ADDENDUM NO. 5

Re: Arch Job Number 24001, DCM #2025238, – Plans Dated: 3/31/25

New Lincoln Police Department

ADDENDUM ITEMS:

E10.1

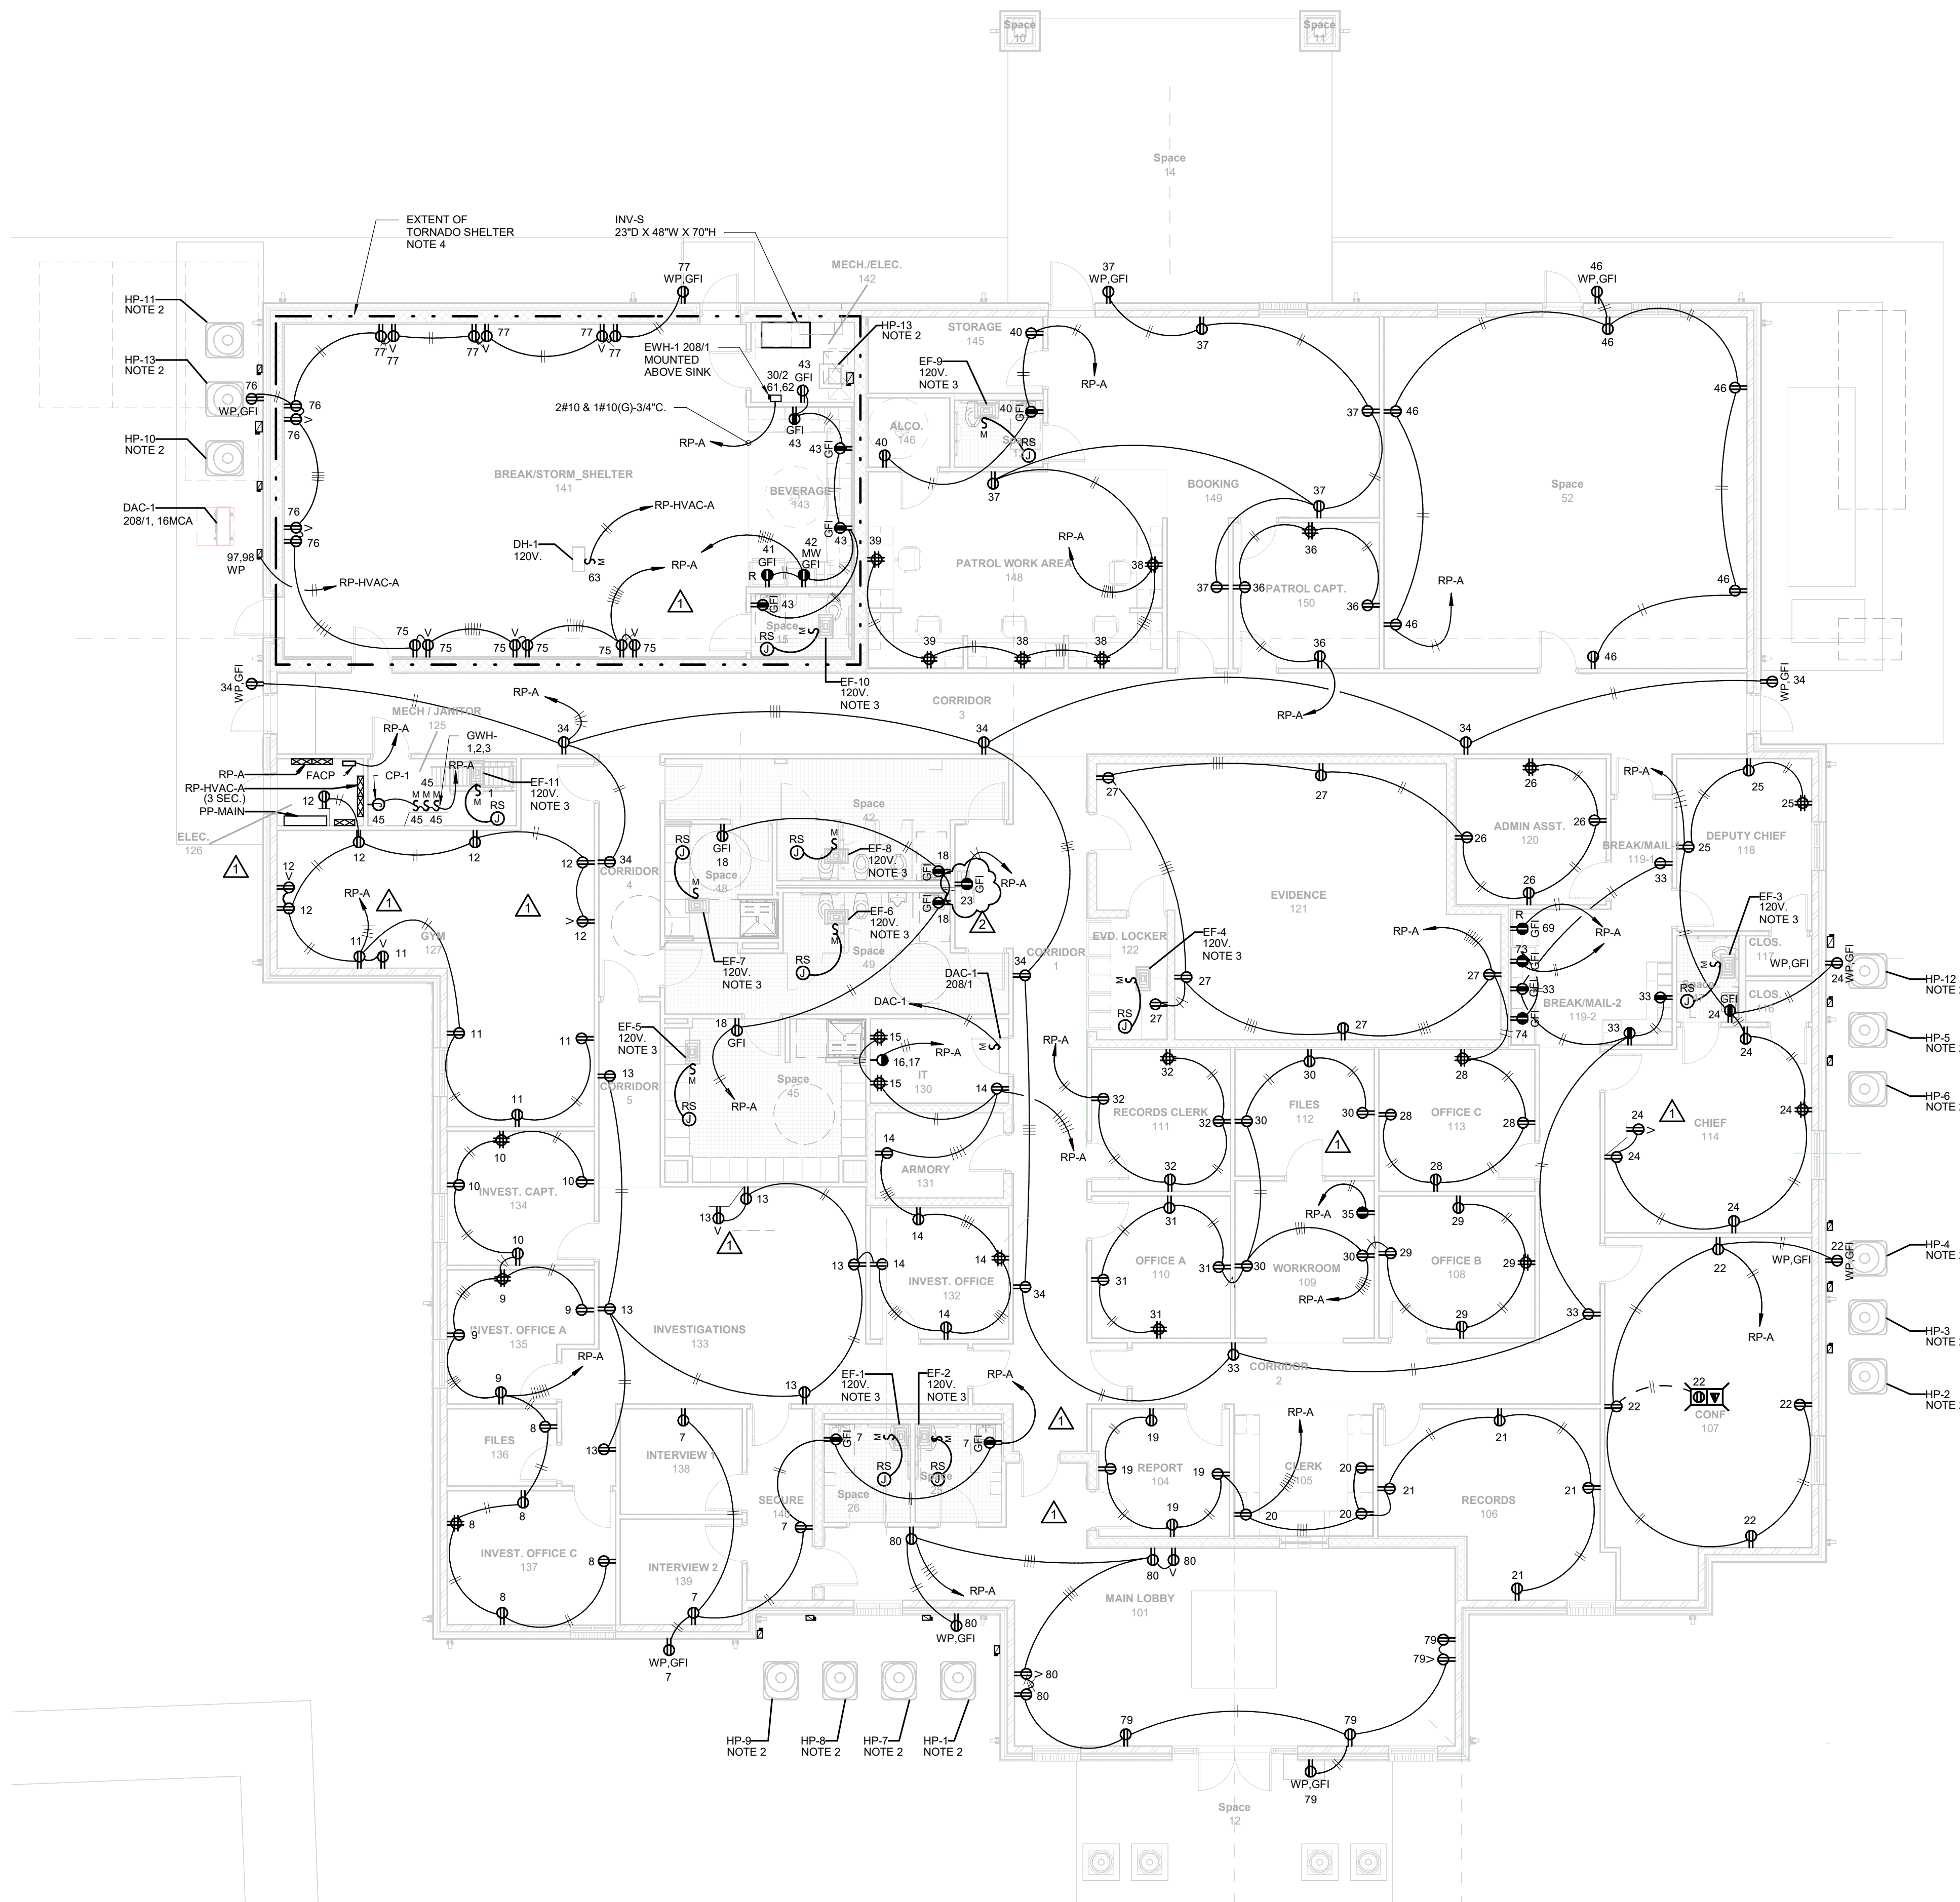
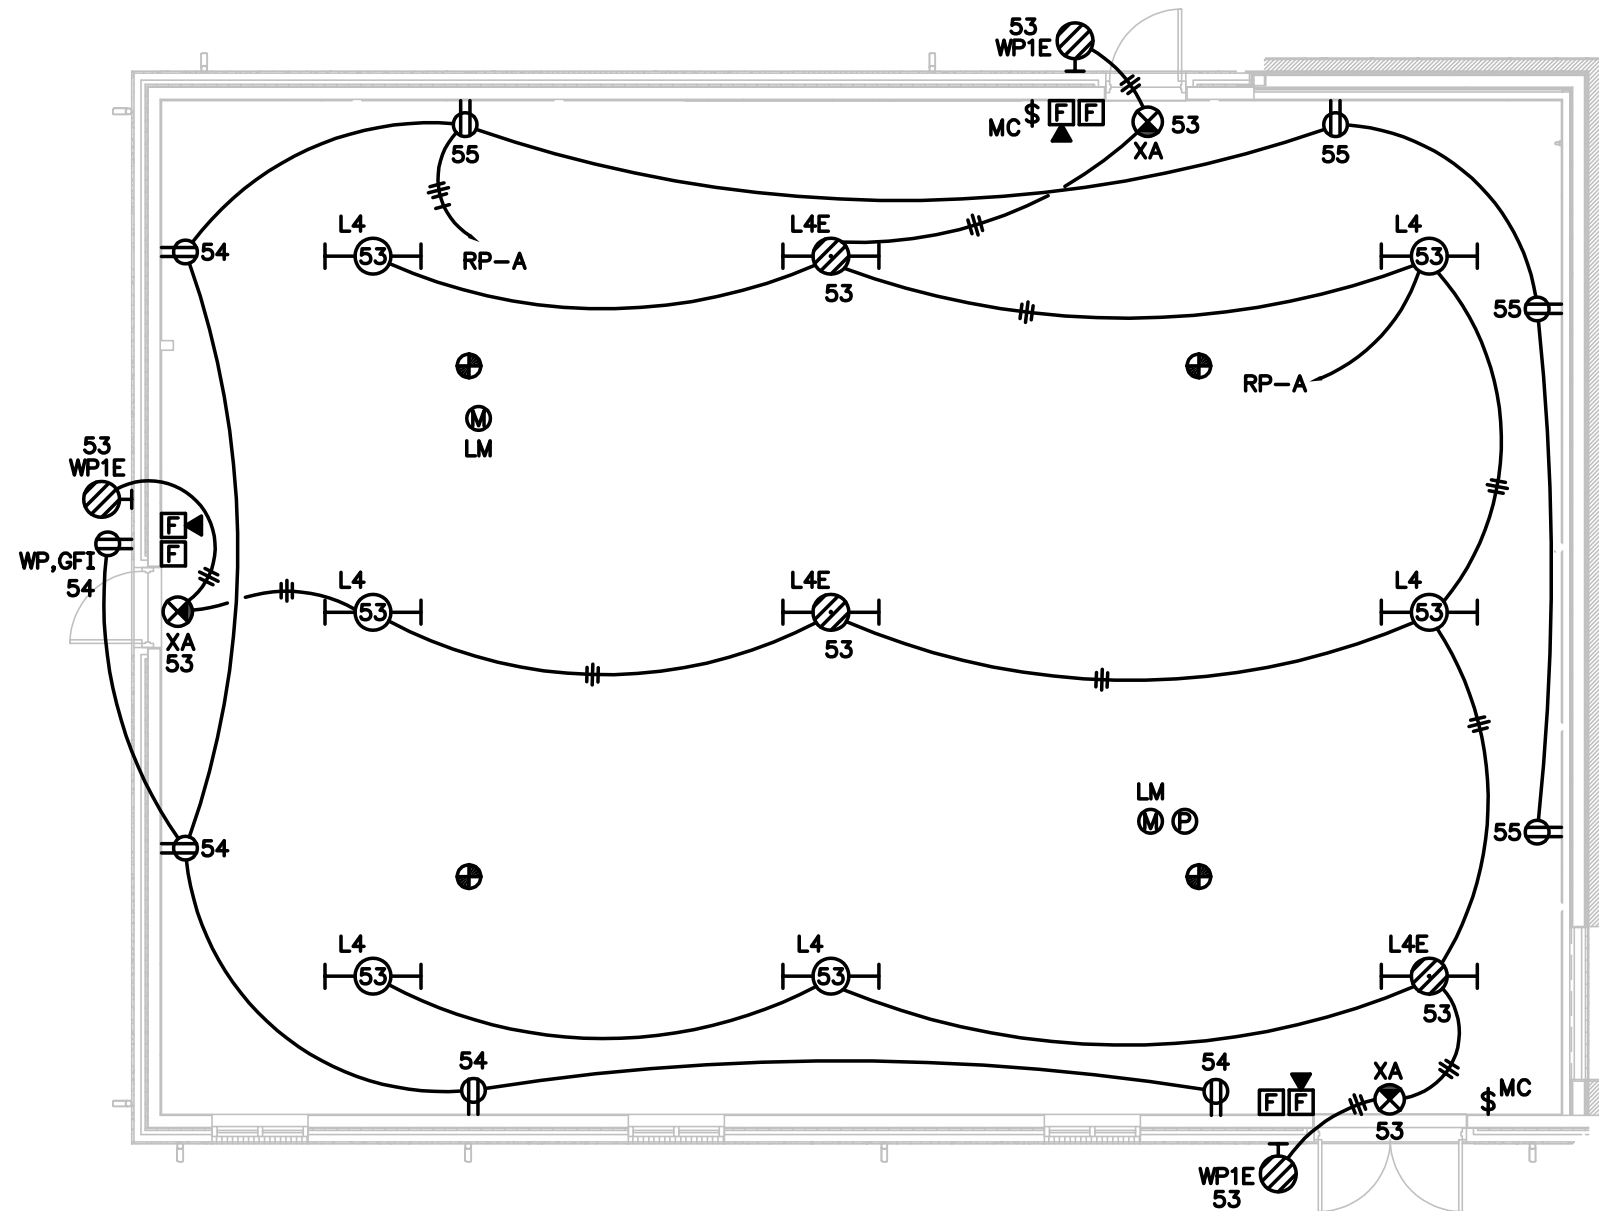
1. LIFE E10.1: Drinking water coolers and bottle fill stations shall be protected with ground-fault circuit-interrupter protection. NEC (2020) 422.5(A)(2).

Comment No. 1: E10.1 - Drinking water coolers and bottle fill stations shall be protected with ground-fault circuit-interrupter protection. NEC (2020) 422.5(A)(2).

Response: GFCI outlets have been shown in revised drawings. (issued in Addendum)
2. ADA E11.0: Make electrical and audio provisions for assisted listening system receivers that comply with 2010 ADA Standards (2010) 219.3 and Table 219.3. Coordinate with architect and verify requirements. Note that other than in courtrooms, assistive listening systems shall not be required where audio amplification is not provided. 2010 ADA Standards 219.2.

Response: GFCI outlets have been shown in revised drawings.
